**Regarding: Grove Street Residences – 121
MassDEP File No. 159-1286
Notice of Intent Peer Review**

RJ O’Connell & Associates (RJOC) and Lucas Environmental (LE) have reviewed the comments issued by BETA Group, Inc. (BETA) within their second peer review letter dated May 1, 2024, and have prepared responses in this letter and included attachments, as necessary.

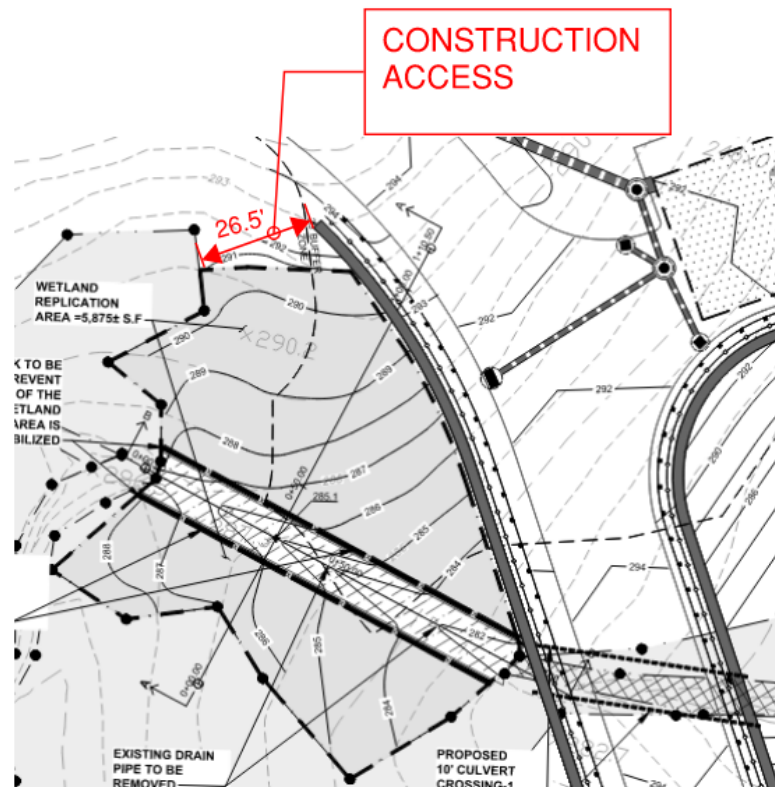
BETA2: Comment remains. To prevent unnecessary compaction of the soil in the location of the wetland replication area and to establish mitigation areas early on in the Project's schedule, BETA advises against use of this area as a temporary settling basin during project construction. As previously noted, access will be limited following the construction of the roadway and the adjacent drainage swale.

RJOC-2: As discussed during the Public Hearing on May 2, 2024, this area is required for access to the upland areas across the stream and necessary for use for construction of the new stream/wetland crossing. It is not feasible to construct the replication area prior to construction of the new crossing as there is no other viable access to the northern side of the stream. Additionally, relocation of the temporary sediment basin would likely require additional impacts to the 100-Foot Buffer Zone and the 25-Foot Buffer Zone. Upon completion of the use of the temporary sediment basin, the soils will be removed and appropriate wetland soils will be placed to construct the wetland mitigation area. Compaction is not a concern in this area and can be addressed during the wetland replication area construction if necessary.

Once the roadway has been constructed the drainage swale and temporary sediment basin will be removed, as the drainage infrastructure will be installed within the roadway (with siltsaks installed in the catch basins). This will allow for a 26.5' wide access path between the retaining wall and the limit of work line to allow for the construction of the replication areas, as depicted below:

Regarding: Groundwater Mounding Analysis (PSIS-1/SWB-1)
121 Grove Street
Franklin, MA

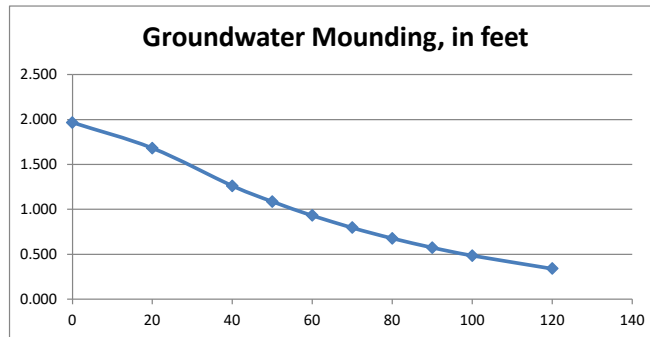
Per BETA Group Inc's Peer Review letter, dated May 1, 2024, Comment SW4 requests a mounding analysis is to ensure Proposed Stormwater Basin-1 (SWB-1) does not have an impact on the groundwater levels below Proposed Subsurface Infiltration System-1 (PSIS-1). A mounding analysis was performed in accordance with Volume 3, Chapter 1 of the Massachusetts DEP Stormwater Standards to demonstrate:

The resultant groundwater mounding peaked at 1.9 feet above the elevation at the spillway crest of SWB-1 to elevation 291.4. The bottom of the infiltration system is proposed at elevation 293.67, providing a 2.27' separation from the bottom of PSIS-1 to the assumed groundwater mound and will not restrict the ability of the system to infiltrate.

Figure 12.--Probability of water-level range in sand and gravel in valley flats

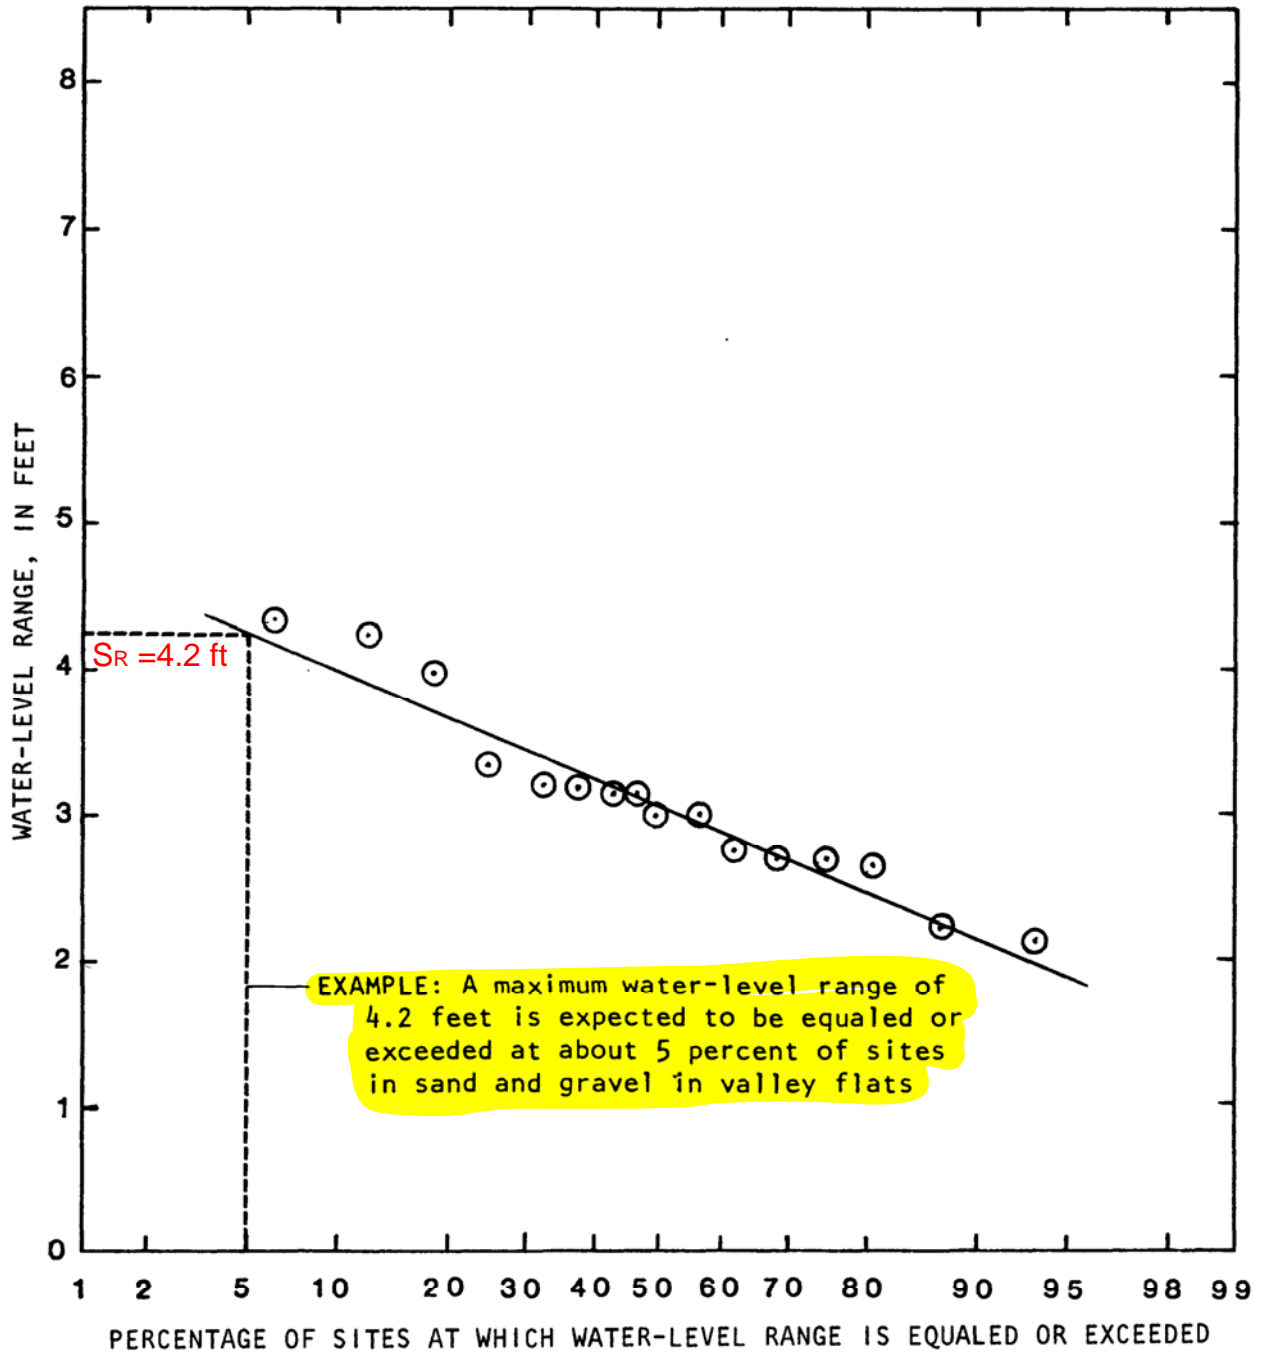
Per BETA Group Inc's Peer Review letter, dated May 1, 2024, Comment SW19 requests that a Frimpter Method ESHGW adjustment is conducted for Test Pit-07 due to lack of redoximorphic features during the onsite soil testing observations. The Frimpter Method analysis is typically utilized if test pits were not performed during the months where high groundwater is anticipated (March-April) and an adjustment to observed groundwater outside this period is required.

To estimate the depth of probable high-water level within Test Pit-07, the S_R value from Figure 12, "Probability of water level range in sand and gravel in valley flats" was utilized, yielding a S_R value of 4.2 the resulting S_H value is calculated to be 5.8 feet (70 inches) below the ground surface, as illustrated below:

Given the existing grade of the site at Test Pit-07 (281.5) the Frimpter Method yields an estimate seasonal high ground water elevation of 275.7.
